Final Set, Jefferson Village Phase II  
(Bulletin 6)

JEFFERSON VILLAGE

TYPICAL PAVEMENT CROSS SECTIONS

HOR. SCALE: NO SCALE  
VER. SCALE: NO SCALE  
DATE: 3-27-00  
JOB NO.: DE99011  
FILE NO.: DE9911X1  
SHEET NO.: P-0.2

JEFFERSON VILLAGE  
 INTERSECTION DETAILS  
 HARDING AVE.

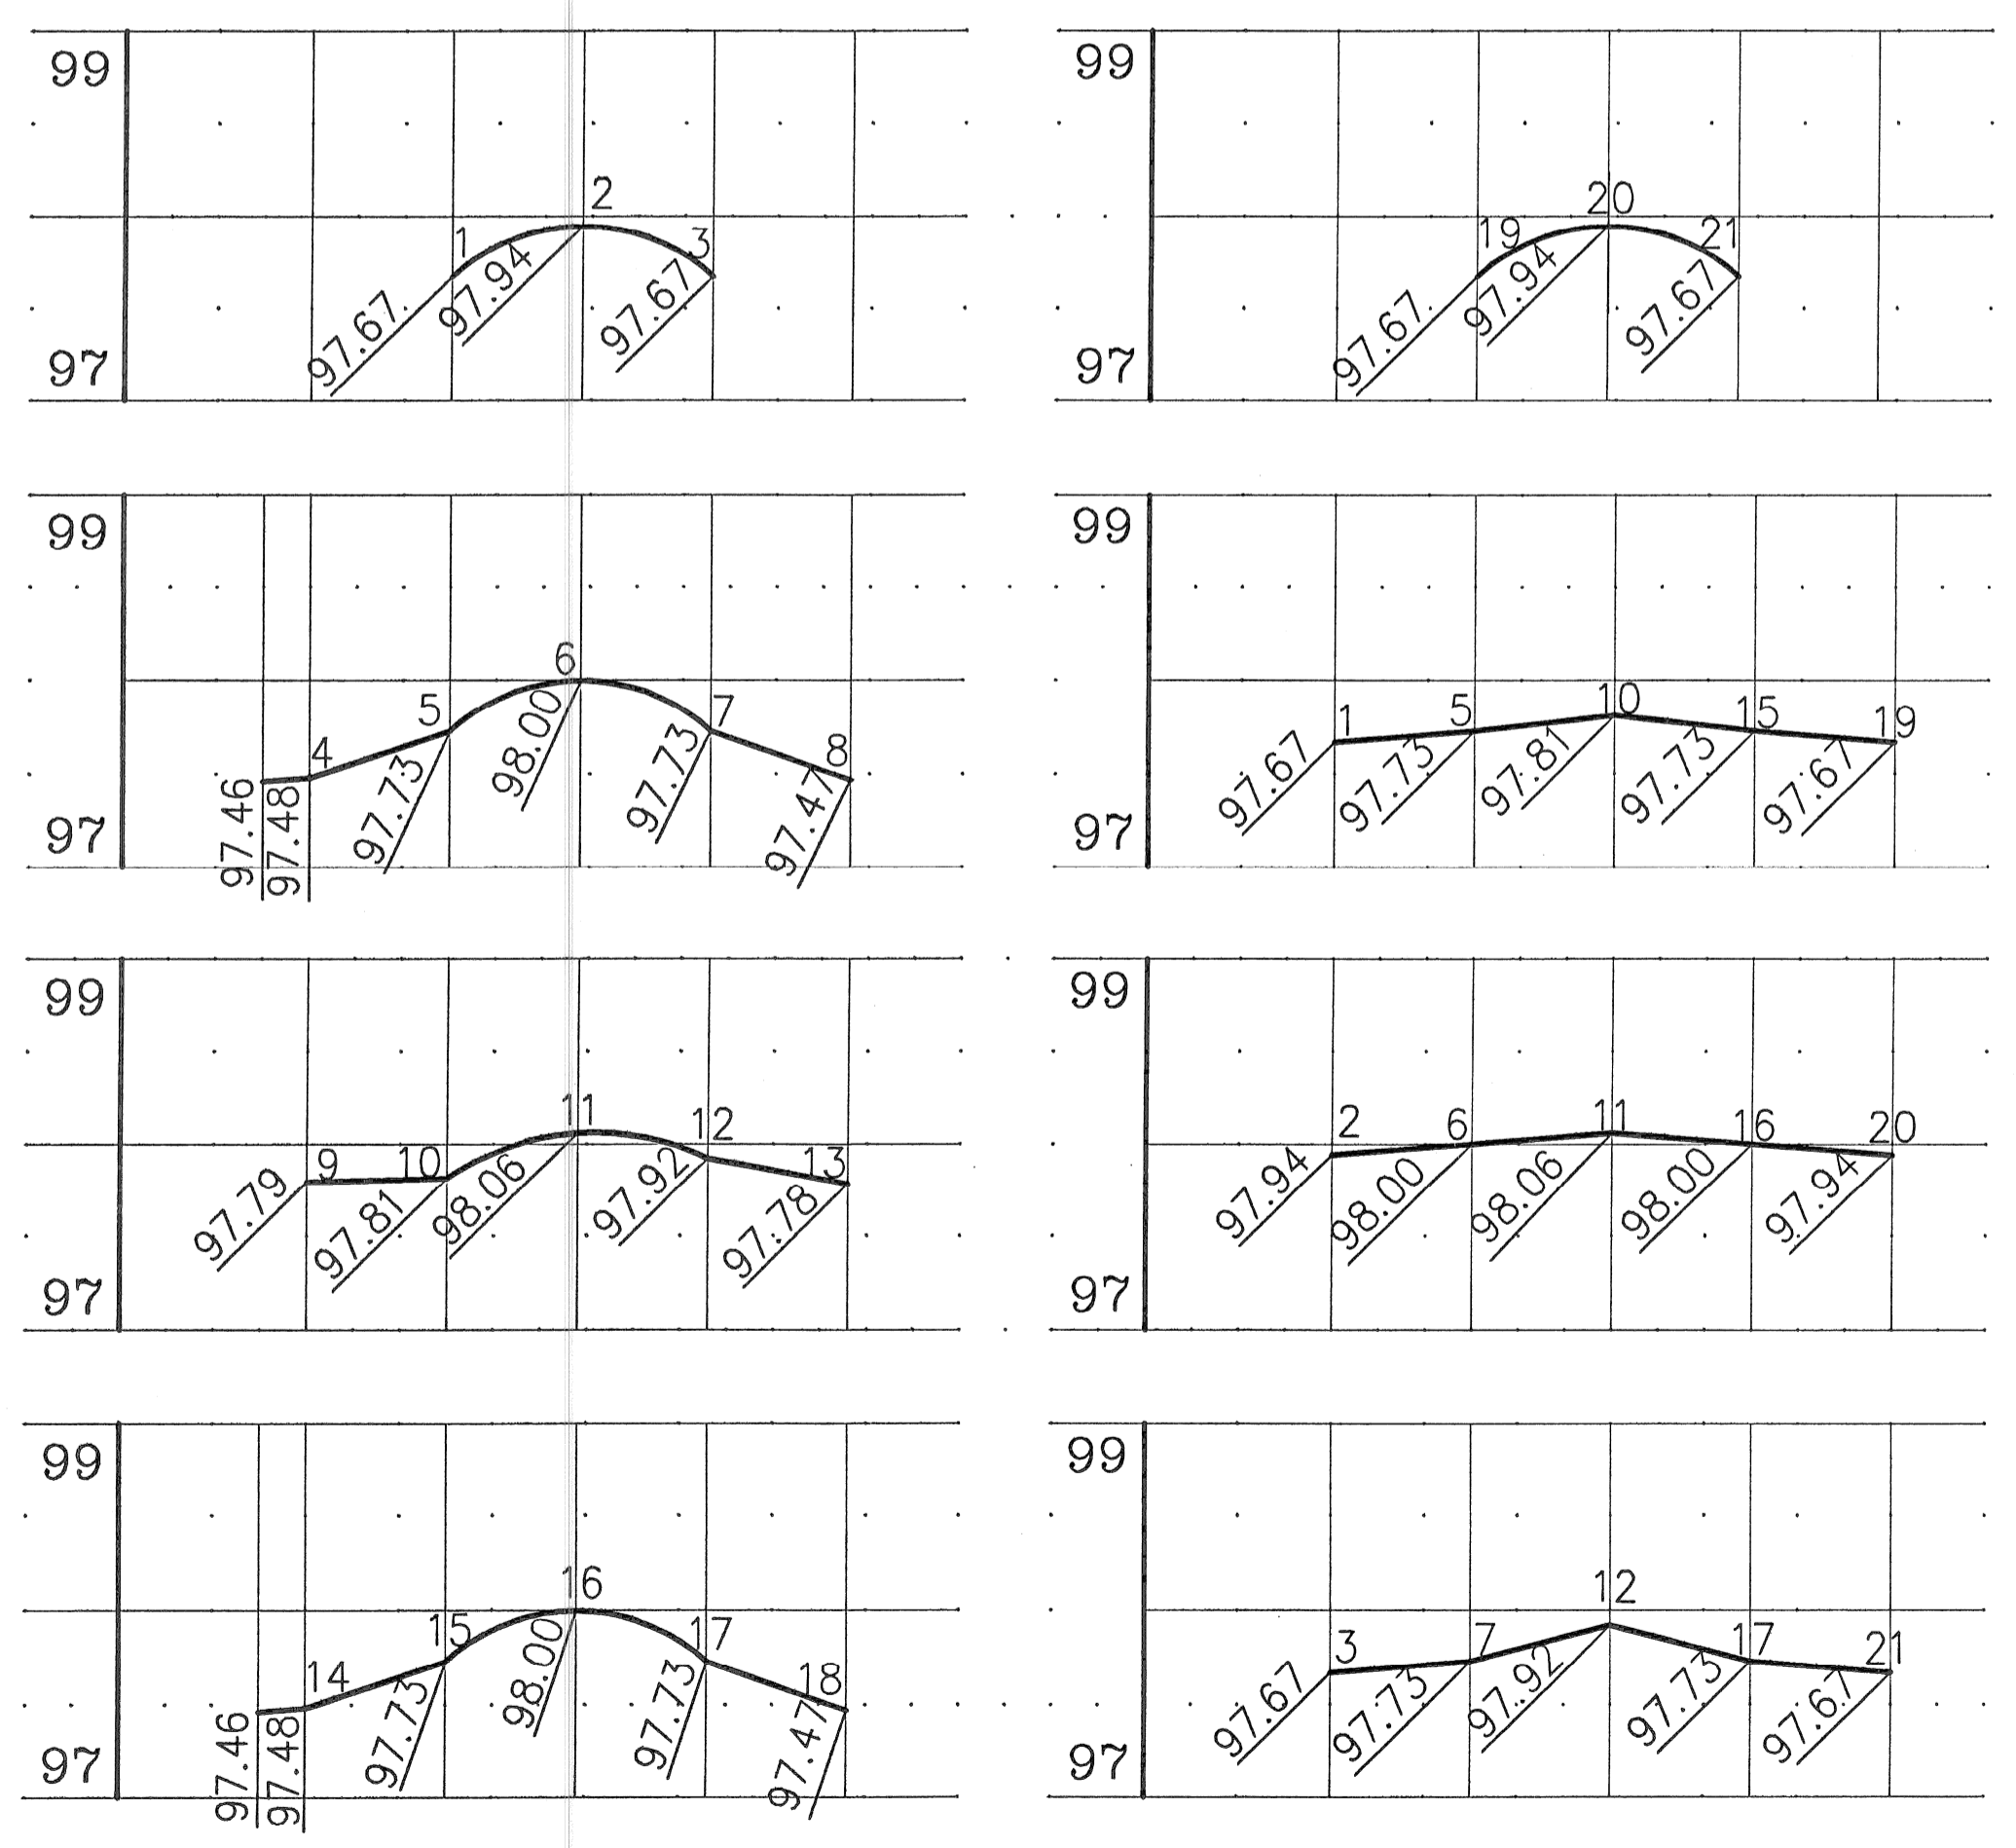
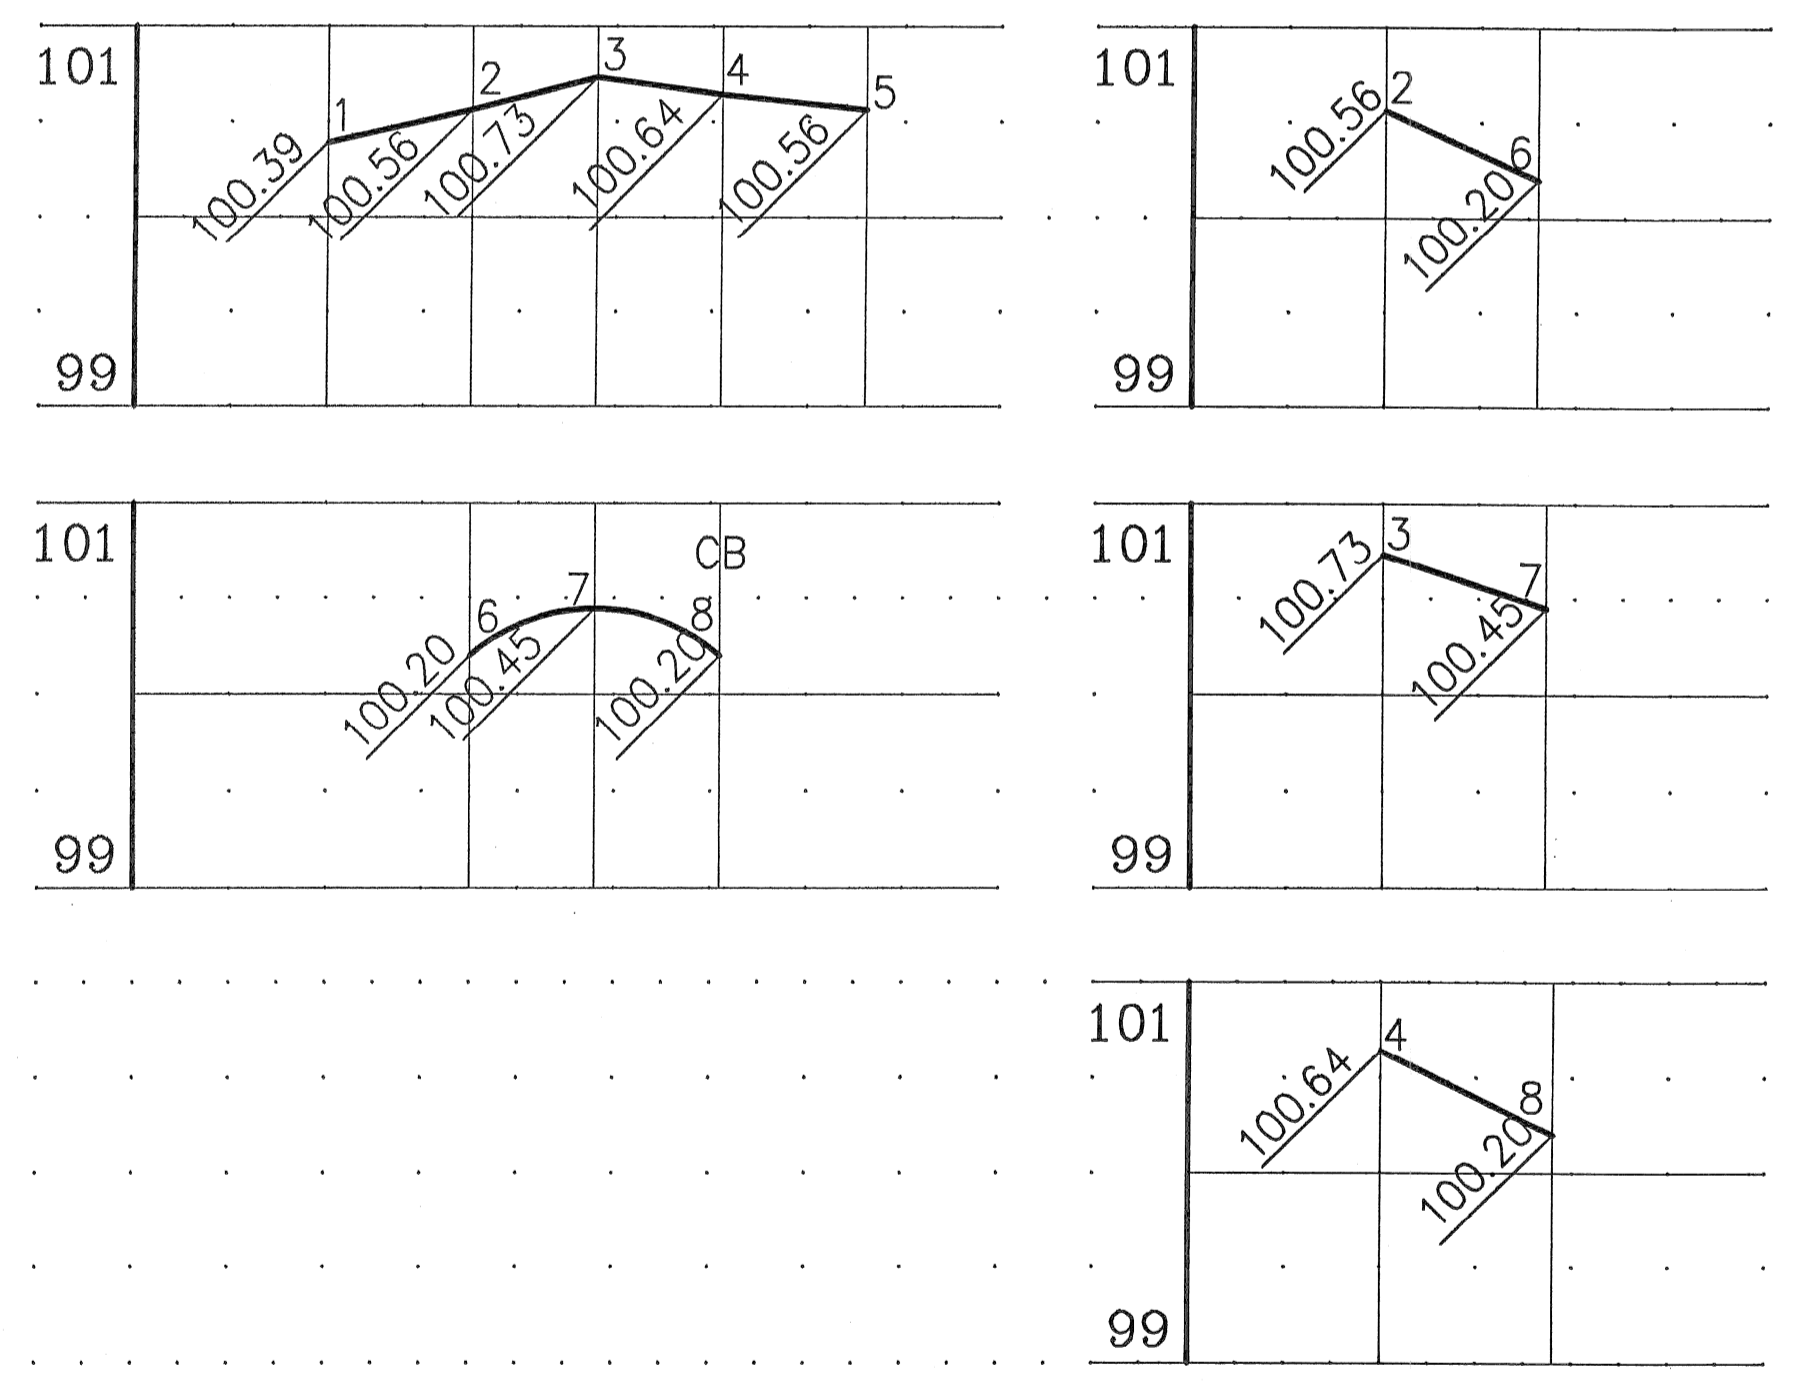
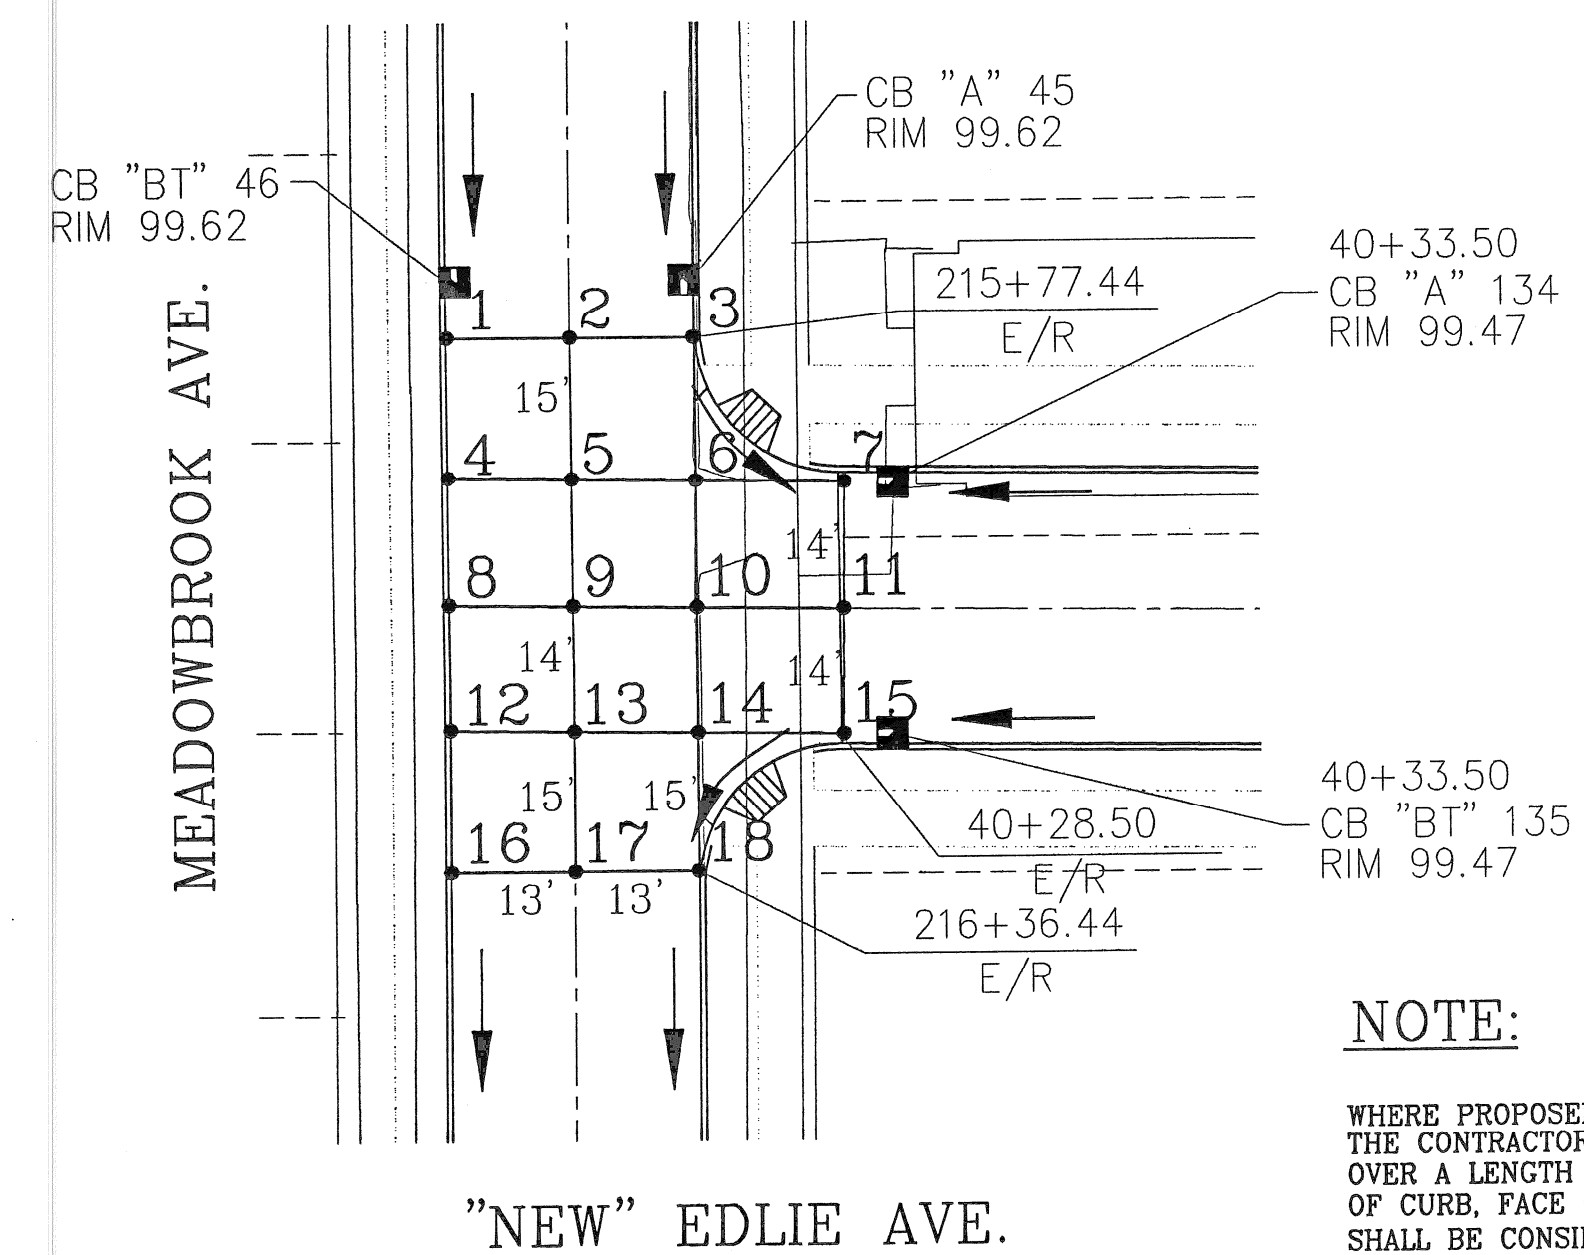
**NOTE:**  
 WHERE PROPOSED ROLL CURB TIES INTO EXISTING CURB/7" HIGH CURB THE CONTRACTOR SHALL TAPER DIMENSIONS OF THE PROPOSED CURB OVER A LENGTH OF FIVE (5) FEET TO MATCH THE EXISTING/7" HIGH TOP OF CURB, FACE OF CURB AND BACK OF CURB. PAYMENT FOR THIS WORK SHALL BE CONSIDERED AS BEING INCLUDED IN THE COST FOR ALL OTHER CONCRETE PAVEMENT WORK.
